**QUALITY****ATV  
WARRANTY  
Bulletin**

December 22<sup>nd</sup>, 2011 Subject: **Alpine Flex Push Frame Quick Attach Update**

No. **2012-4**

vbg2012-005-007\_a

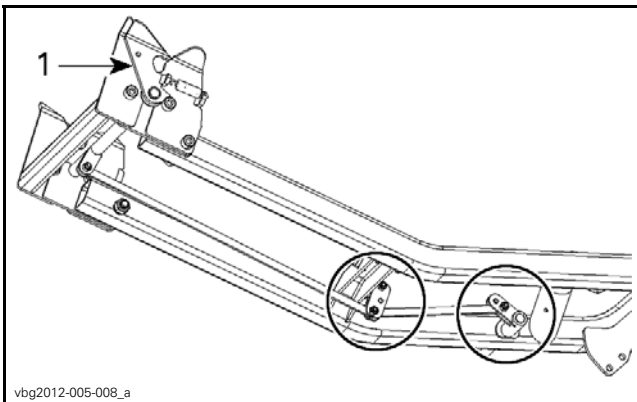
1. Before working on a push frame already installed on a vehicle, verify if the quick attach system was already updated:

**QUICK ATTACH SYSTEM THAT NEEDS TO BE UPDATED**  
1. Black painted hooks

**UPDATED QUICK ATTACH SYSTEM**  
1. Zinc plated hooks

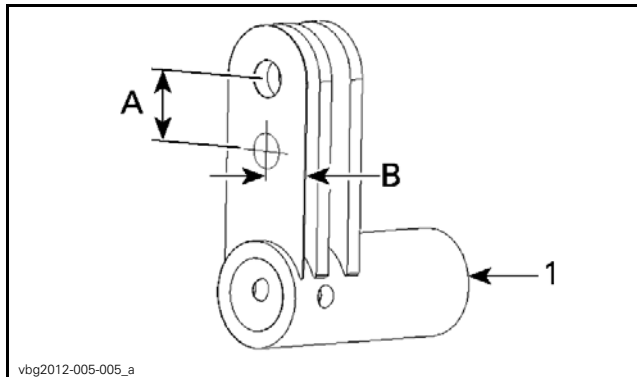
- Drill a 6.35 mm (1/4 in) hole through the front lever using the following dimensions or the template attached on the last page of this bulletin.

- Front lever
- A. 12.7 mm (1/2 in)
- B. 9.52 mm (3/8 in)

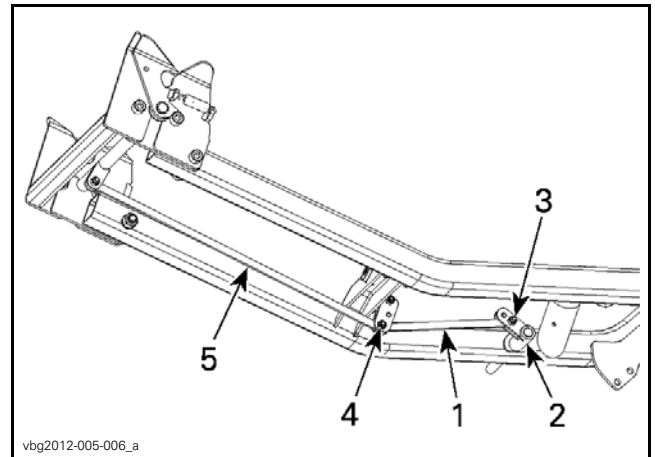
- Reinstall the front lever using a **NEW** spring pin. For the following steps, do not overtighten.
  - Allow link bars and lever to rotate freely
  - Avoid parts deformation.
- Reinstall the front link bar in the hole newly drilled in the front lever. Use a **NEW** elastic stop nut.
- Install both front and rear link bars in the lower pivot hole using:
  - Provided M6 X 2.5mm screw
  - NEW** elastic stop nut.
- Reinstall the rear link bar on the hook assembly using a **NEW** elastic stop nut.

- Front link bar
- Front lever
- Bolt in the newly drilled hole
- Front and rear link bar in the same hole
- Rear link bar
